Futaba

T7PX/T7XC Software Update Method

Improvement in SR mode setting

"S.Bus servo" screen of version V2.0 to V2.2

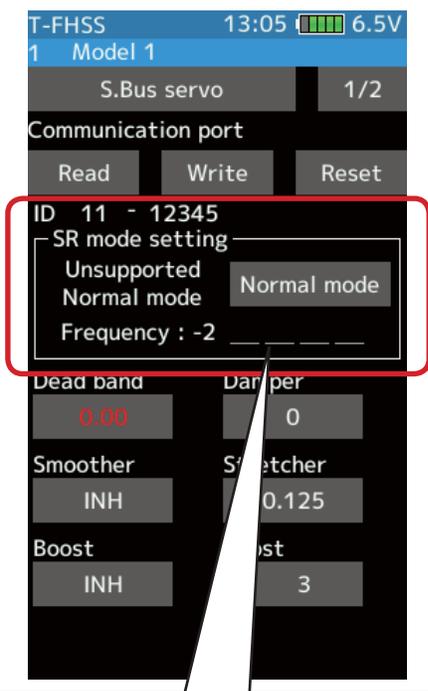
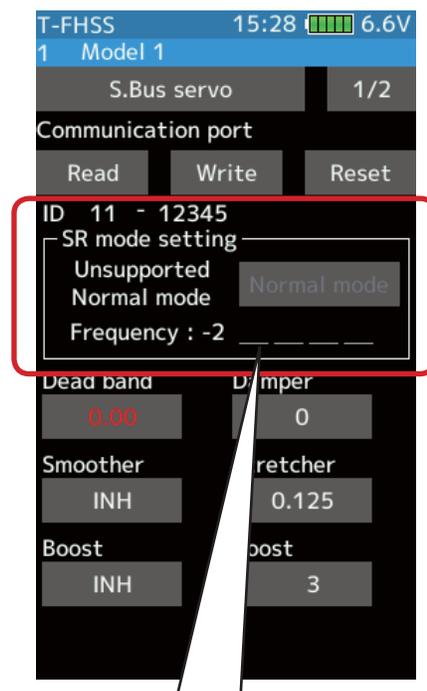
Even if a servo that is not compatible with SR mode is connected to a T7PX/T7XC with softwareV2.0 to V2.2, the transmitter can switch the servo to SR mode, but the incompatible servo will not work and the servo program is damaged when you forcibly switch the servo to SR mode. Thus, the servo does not work. So, please never switch when you connect an incompatible servo to SR mode.

Even if a servo that is not compatible with SR mode is connected, you can switch the servo to SR mode, but the servo will not work and damaged if you switch it to SR mode

When connecting a servo that is not compatible with SR mode, a message "Unsupported" is displayed on the screen, but you can operate the SR mode select button.

Please never select the SR mode setting when you see "Unsupported" on the display.

The software has been improved so that a transmitter prohibits you from switching an incompatible servo to SR mode.

If you connect a servo that is not compatible with SR mode, the screen forbids you switching it to SR mode.

When connecting a servo that is not compatible with SR mode, you cannot operate the SR mode switching button.
